RE: Windfall Oil & Gas, Inc.
Permit # PAS2D020BCLE
PERMITTED FACILITY: Class II-D injection well, Zelman #1

PETITIONER RICHARD L. ATKINSON'S MOTION FOR LEAVE TO FILE A REPLY TO REGION III'S RESPONSE TO PETITIONS FOR REVIEW

CNX Gas Company sign on well # 033-20333

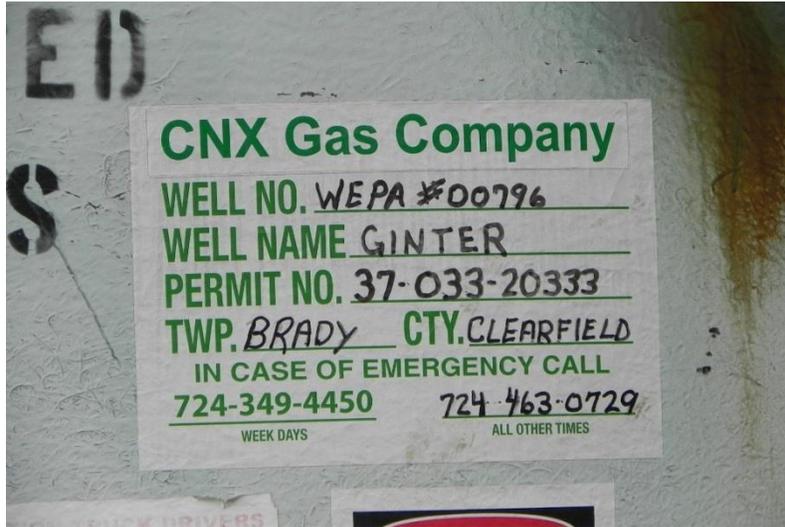
After the public comment period had expired, the Region announced for the first time that they may modify the Area of Review (Administrative Record, CC 2014 response to comments, page 16, end of 2nd paragraph). The regulations do not require the Region to make the Area of Review larger than the original ¼ mile radius circle. If anything, the Region would have incentive to make the Area of Review smaller, in order to maximize the amount of natural gas that the gas leaseholder can harvest by horizontal drilling and hydraulic fracturing of the Marcellus Shale. All of the conventional gas wells in the area of the proposed disposal injection well have CNX on their labels. See exhibit A. Therefore, Windfall Oil & Gas does not own the gas rights and CNX would have to cooperate by allowing Windfall to infringe upon CNX’s gas rights.
